Dell OptiPlex® GX1 and NX1

**DOCUMENTATION
UPDATE**

August 1998 P/N 4485C Rev. A05

Dell[®] OptiPlex[®] GX1 and NX1 Documentation Update

Figure 1-2. System Board Features

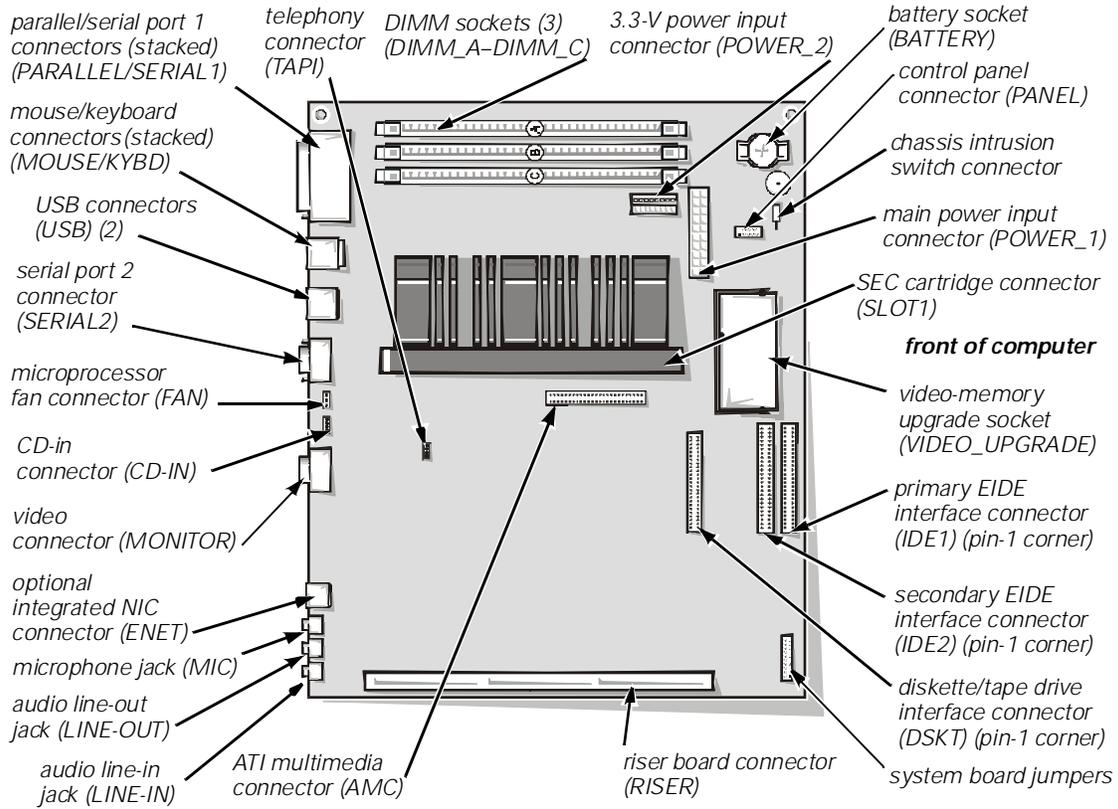
New OptiPlex GX1 and NX1 systems contain the system board shown in Figure 1-2.
